# Service Bulletin

Bulletin No.: 24-NA-032

**Subject:** Poor Fitting Charge Port Door and/or Charge Port Door Sticks Out at Bottom

6550661

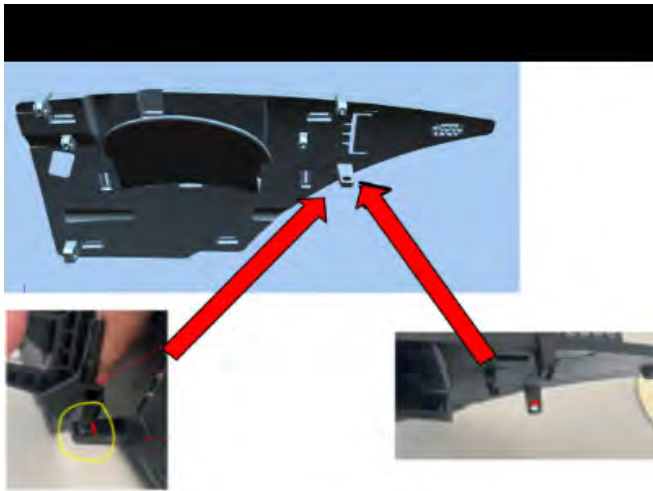
6. Sand down all the protruding rectangle slots till they are flush with the surrounding areas like pictured above.

6550663

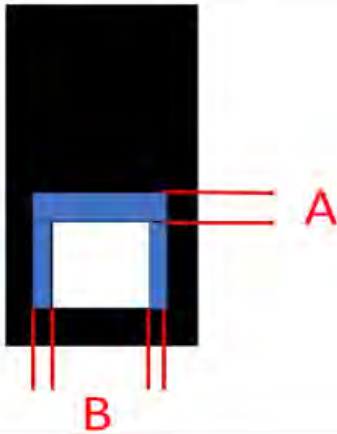
8. While the charge port door is open, use a suitable file, elongate the existing hole shown on the charge port housing. Elongate the hole to the red line.

6553039

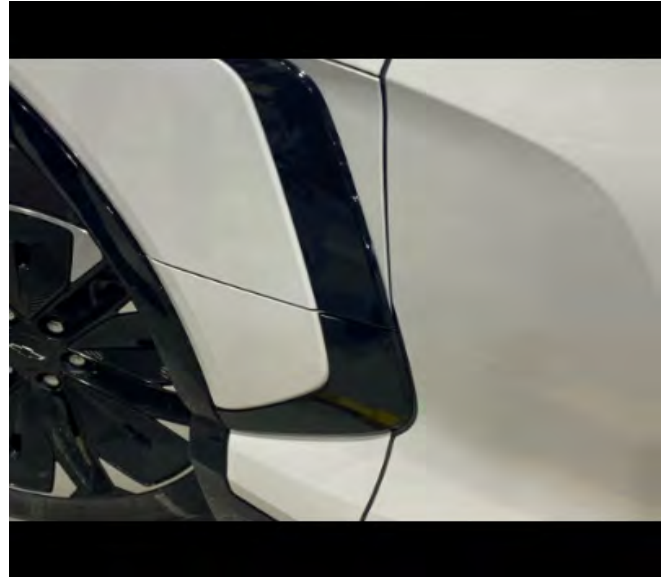
The illustration above shows the amount of material needed to be removed. 1.6 mm on the side illustrated with the (A) , and 0.25 mm from the two sides (B). The final measurements should be 6.81 mm by 6.6 mm.
